Number: ATE-12-19

Subject: Mandatory Inspection for T40173 Gearbox Mount
Update Conversions

Date: Nov. 2, 2012

Supersedes ATE-12-17 dated October 26, 2012 due to incorrect modification picture.

Area of Modifications (Red)
T40173
Gearbox Support Tool

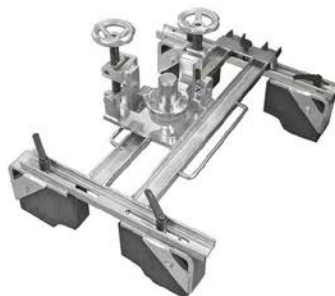
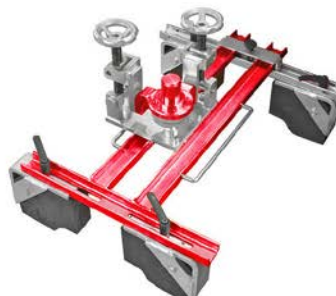
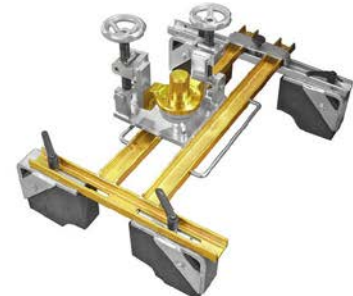
Before using the T40173 gearbox mount, it must be checked whether the update exchange of the base carrier and joint mounting (**components marked red**) described in Audi Tools circulars ATE-08-16 (Sept. 4, 2008) and ATE-11-56 (Nov. 3, 2011) have been carried out. For clear recognition, the revised components have been coated with yellow chromate for corrosion protection.

If the described conversions have not been carried out on your gearbox mount, this can easily be recognized by the color of the surface coating. Gearbox mount components that have not been updated are galvanized as standard – the surface of all components is silver. We explicitly point out that using the unconverted/unmodified version can lead to personal damages as a result of the prevailing risk of injury.

Unconverted/Unmodified T40173 gearbox mounts must not be used under any circumstances!
